# Access Compliance Report

## Public Rights-of-Way

### (Curb Ramps)

Intersection ID: 5623	Main Street: FOREST_SIDE_LN	Cross Street: HANBERRY_BV	Location: SE
ADA ID: CBCCF6095DE6	Ramp Type: PerpDiag	Initial Pass/Fail: Fail	Overall Compliance: No
Severity Score: 1.25			
Codes/Mitigation Info/Possible Solution		Field Measurements/Component Compliance

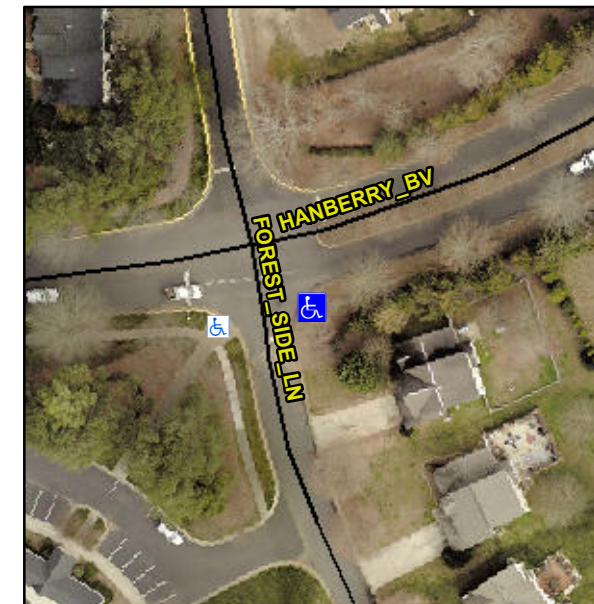
**Not Found, R304.5.3**

Compliance	Description	Data	Compliance	Description	Data
N/A	Ramp Length (in)	96.0	Yes	Ramp Slope (%)	5.0
Yes	Ramp Width (in)	60.0	No	Ramp XSlope (%)	2.8
N/A	Flare Type LT	N/A	N/A	Flare Type RT	N/A
N/A	Flare Slope LT (%)	N/A	N/A	Flare Slope RT (%)	N/A
N/A	Flare Traversable LT?	N/A	N/A	Flare Traversable RT?	N/A
N/A	Landing Length (in)	N/A	N/A	DWS Provided?	N/A
N/A	Landing Width (in)	N/A	N/A	DWS Contrast?	N/A
N/A	Landing Slope (%)	N/A	N/A	DWS Length (in)	N/A
N/A	Landing X Slope (%)	N/A	N/A	DWS Full Width?	N/A
N/A	Landing Curb? (Y/N)	N/A	N/A	DWS Offset (in)	N/A
N/A	Shared Landing?	N/A			
N/A	Gutter Ponding?	N/A	N/A	Gutter Slope (%)	N/A
N/A	Gutter Lip Ht (in)	N/A	N/A	Gutter X Slope (%)	N/A
N/A	Painted X Walk1?	No	N/A	Painted X Walk2?	No
	X Walk 1 Direction	To N		X Walk 2 Direction	To W
N/A	X Walk 1 Width (in)	N/A	N/A	X Walk 2 Width (in)	N/A
	X Walk 1 Slope (%)	0.5		X Walk 2 Slope (%)	4.9
	X Walk 1 X Slope (%)	4.7		X Walk 2 X Slope (%)	0.7

**Remove & Replace Curb Ramp With Two New Directional Ramps or Equivalent.**
